Service Information

| Category S | Repair Guidance | Ref. No. R010/14A | Page 1 of 2 |
| Applicable Model Mazda6 (GJ) | | Applicable Countries or Specifications Worldwide | |

Subject: Bonnet vibrates when driving at more than 110 Km/h

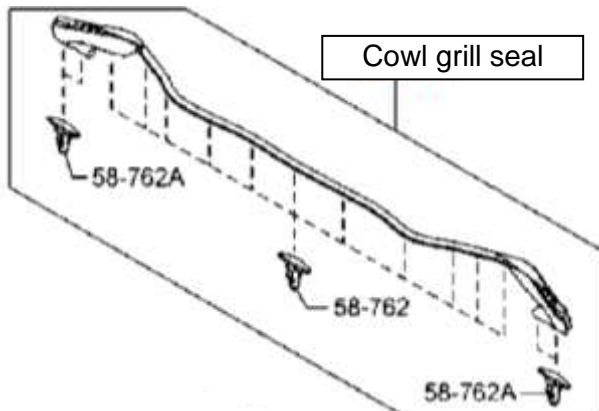
The preload forces of the cowl grill seal may be insufficient which can also affect the bonnet vibration adversely.

The preload force of the cowl grill seal has been increased to reduce bonnet vibration.

Replace the cowl grill seal with a modified one with increased preload force.

Note: The cowl grill seal is attached to the cowl grill with clips.
